**WOODCREEK SUBDIVISION,**  
**HIDDEN LAKES SUBDIVISION,**  
**AND**  
**SWEETWATER SUBDIVISION**

The purpose of this application is to create three subdivisions totaling 371 lots from five parcels.

APPLICATION NUMBER 41 & 42 & 43 DATE June 7, 2007

## DETAIL SITE PLAN

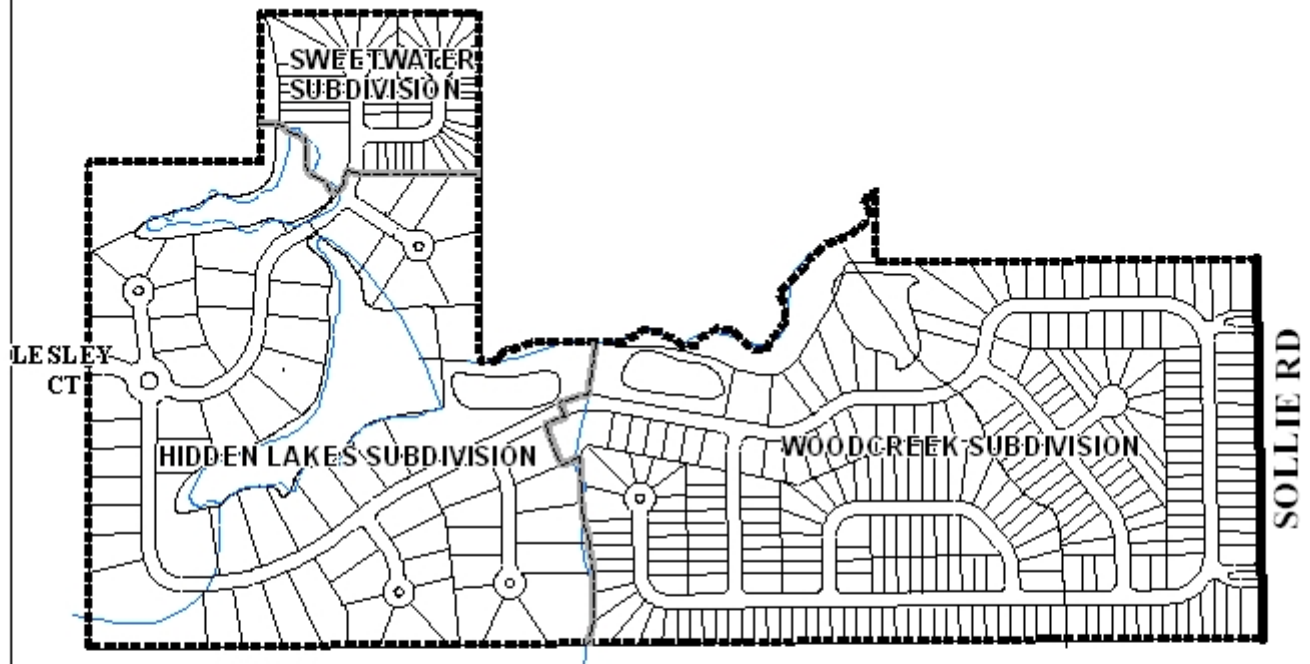
Access management is a concern as it relates to public safety. The three combined subdivisions, as proposed, will have only three connections to existing public streets. No additional street-stubs are proposed, even though two street-stubs exist off of Tara Drive West and South. Also, three parcels to the South of the site are large enough to warrant street-stub connections,

however, none are proposed. It is recommended that the overall application be reconfigured to provide additional connections to existing public streets and provide street-stubs to the South. Additional street connections will increase the ability of public safety providers to respond to emergency calls within the development.

Common areas are proposed throughout the development, including the round-about, road medians, detention areas and other areas. There also appear to be areas of land that are not lots and are not labeled as common areas: these areas should be specifically identified. All common areas should be quantified in square feet by subdivision, with differentiation of areas set aside for detention. A note should also be placed on the final plat, if approved, stating that maintenance of the detention and common areas is the responsibility of the subdivision's property owners.

Stormwater detention facilities are depicted on the plat. While the site is located in the county, compliance with the City of Mobile stormwater and flood control ordinances will be required. A letter from a licensed engineer certifying compliance with the City's stormwater and flood control ordinances should be submitted to the Planning Section of Urban Development prior to the signing of the final plat, if approved.

- 3) revision of the plat to provide additional street connections to existing street-stubs adjacent to the site, and provision of street-stubs to the undeveloped properties South of the site;

- 4) revision of the plat to label all common areas and any unidentified areas, and provision of a table quantifying common area in square feet by subdivision;

# WOODCREEK SUBDIVISION PLAT

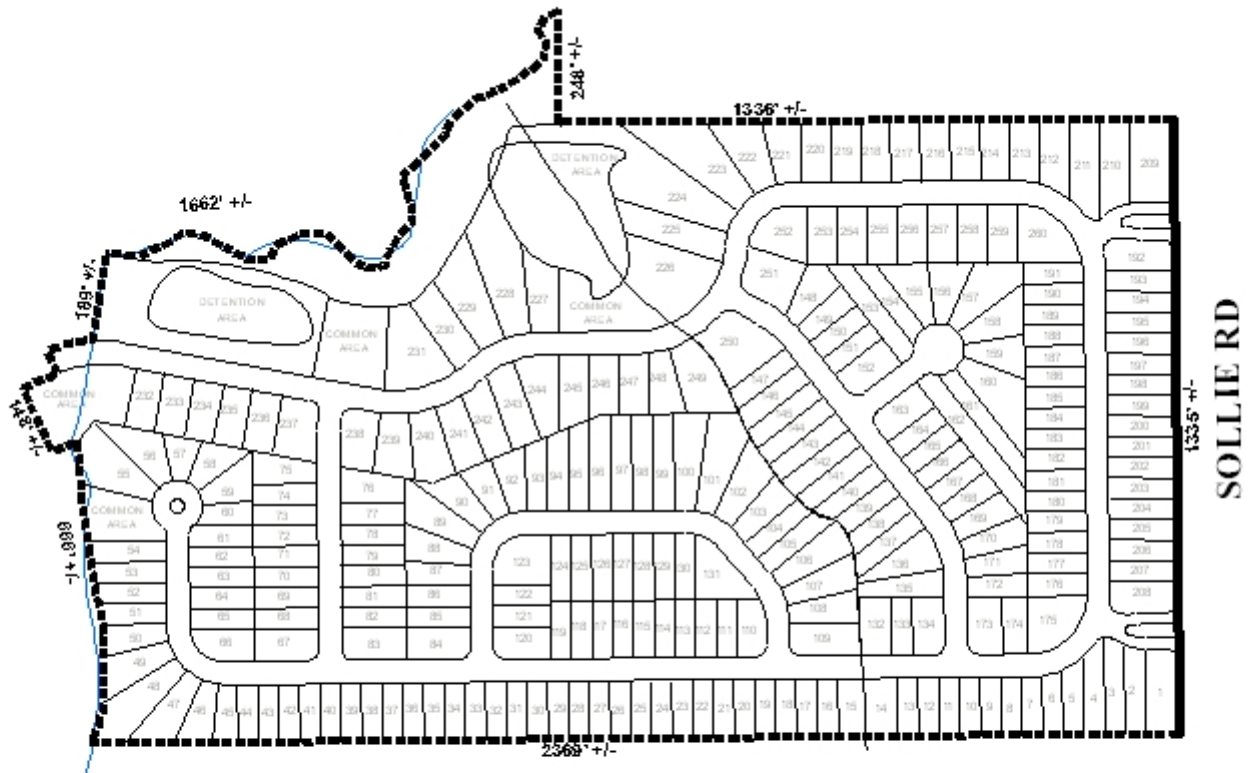
Each subdivision will have a variety of lot sizes, however the proposed Woodcreek and Sweetwater Subdivisions will have a substantial number of lots less than the minimum recommended area of 7,200 square feet, and less than the recommended width of 60 feet. The Woodcreek Subdivision has lots as small as 5,625 square feet and as narrow as 45 feet in width. The Sweetwater Subdivision has lots as small as 3000 square feet and as narrow as 25 feet in width. It appears that all lots proposed for the Hidden Lakes Subdivision meet the minimum size and width standards of the Subdivision Regulations.

- 1) revision of the plats for the Woodcreek and Sweetwater Subdivisions so that all lots meet the minimum lot size requirements contained in Section V.D. of the Subdivision Regulations, or provision of a statement justifying the request for reduced lot sizes and setbacks;
